Andrews - DNR, Doug <doug.andrews@state.co.us>

COGCC Form 2A review for Noble Energy's Wells Ranch State AA33-755 Pad location - Doc #400939986

PERMIT NUMBER 42977

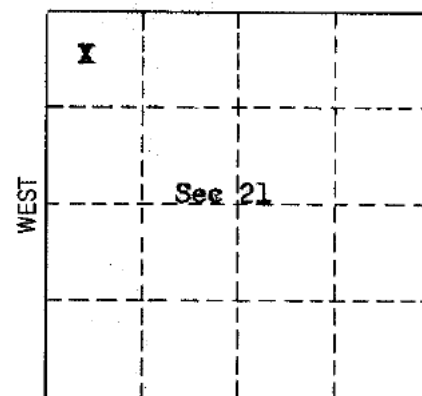
2) In the Water Resources section you have indicated the nearest water well is Permit #287427 approximately 2,926 feet from this proposed Oil & Gas Location and an estimated depth to groundwater of 110 feet. During my review I identified water well Permit #42977 located approximately 2,360 feet north with a static water level of 15 feet. As this water well is at a surface elevation that is 25 feet lower than this proposed Oil & Gas Location, I estimate the depth to groundwater at the proposed Oil & Gas Location to be approximately 40 feet. Therefore, I would like to revise the Water resources section to reflect this information.

Below are the answers to your concerns. Please let me know if there is anything else you need.
